## DEVELOPMENT APPLICATION ASSESSMENT REPORT

<b>Application Number:</b>	DA2021/0139
----------------------------	-------------

<b>Responsible Officer:</b>	Alex Keller
<b>Land to be developed (Address):</b>	Lot 100 DP 817162, 2 Cross Street BROOKVALE NSW 2100
<b>Proposed Development:</b>	Demolition works and construction of a mixed use building accommodating 17 self storage units and 23 industrial units including carparking and landscape works
<b>Zoning:</b>	Warringah LEP2011 - Land zoned IN1 General Industrial
<b>Development Permissible:</b>	Yes
<b>Existing Use Rights:</b>	No
<b>Consent Authority:</b>	Northern Beaches Council
<b>Delegation Level:</b>	NBLPP
<b>Land and Environment Court Action:</b>	No
<b>Owner:</b>	Cross Street Holdings Pty Ltd
<b>Applicant:</b>	Leda Holdings Pty Ltd

Image: Height of building visible along the streetscape frontages and impact on diminishing the landscape setting objective possible for street amenity.

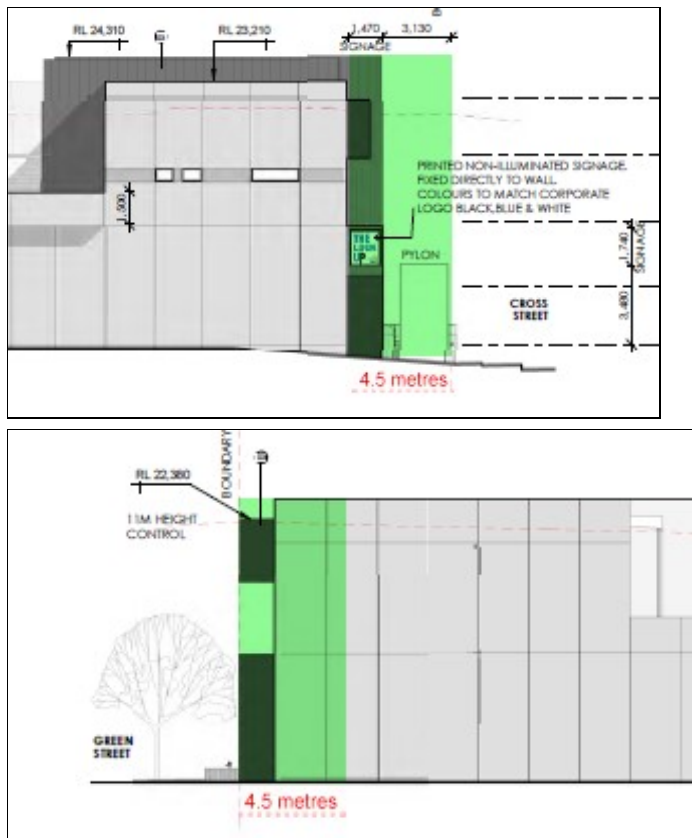
Comment: The proposed building represents a sufficient industrial character however the height and bulk has been over-accentuated above the height control. The character of the area includes an 11m height limit and while there is no storey limit there is a mix of lower single storey and two storey buildings present also. The proposal has not sought to minimise the elements of non-compliance in terms of building elements that extend above the height line and are unnecessary over-extensions of blade walls and parapet elements above the height plane. Placement of the building footprint and upper bulk deliberately within the front setbacks compounds the appearance of building height much closer to the public domain and diminishes opportunities to establish a landscape setting commensurate with the scale of the building to ensure the development does not have an adverse effect on the streetscape and future character. The proposal effectively established defacto build-to lines above the 11m height plane that are also within the front boundary setback area depicted in the image below. This is not supported and diminishes the ability to maintain the industrial character of the land in landscape settings.

Image: Extent of non-compliance along the 4.5m (black dotted) line shown with limited or no area retained for landscape zone in front of the building.

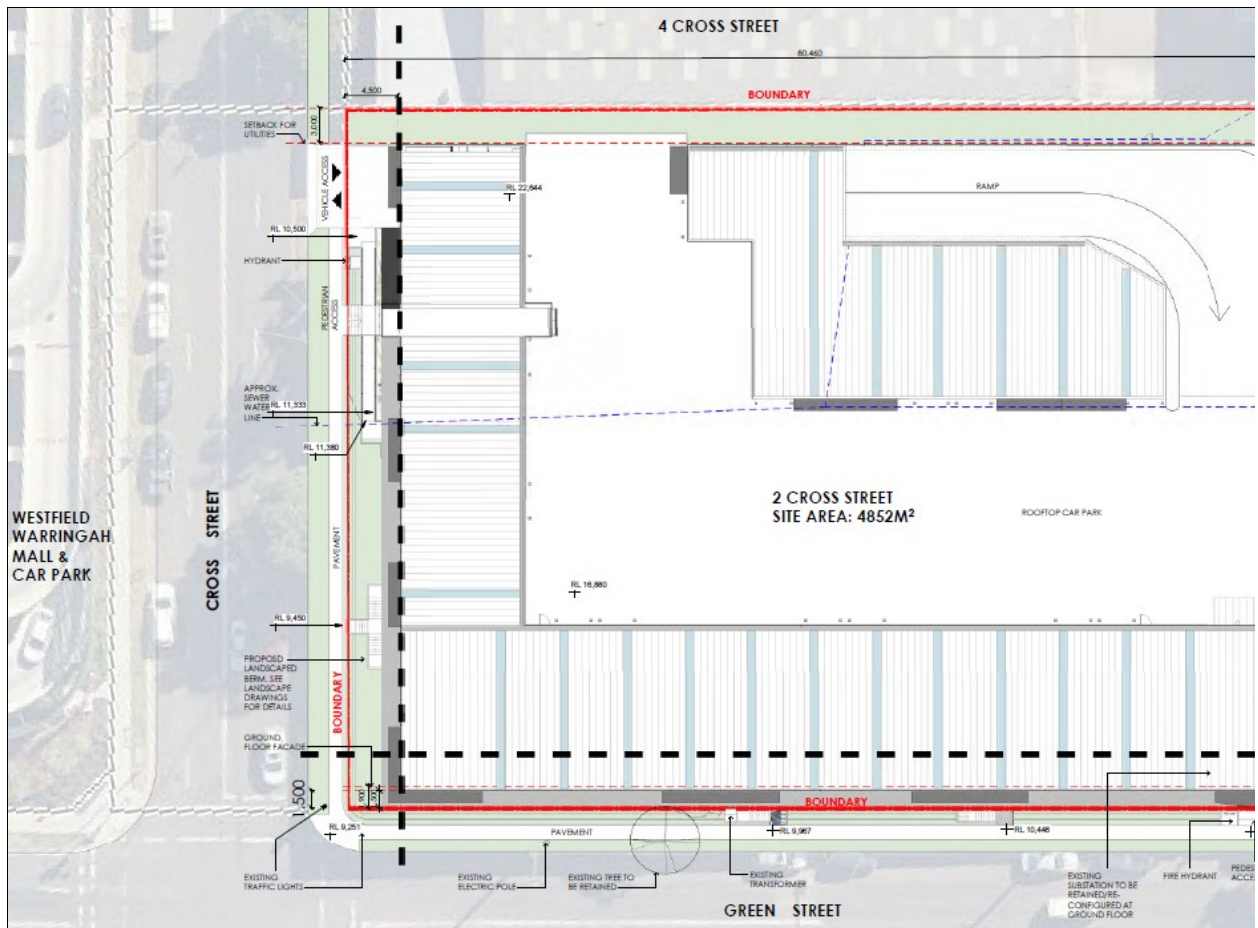
The site is on a corner location within a busy sector of Brookvale and the extent of non-compliance into the front setback along such and extensive double street frontage creates an unfavourable precedent for other future development to replicate, breaking the ability of being able to maintain visual continuity and the same pattern of building elements behind a 4.5m width of landscape elements. The proposal goes against the existing examples of recent development that have complied with the 4.5m front setback and ensured a dominance of landscaped elements along the streetscape for their re-developed frontages. (examples include No.117 Old Pittwater Road, No.1 to 15 Green Street).
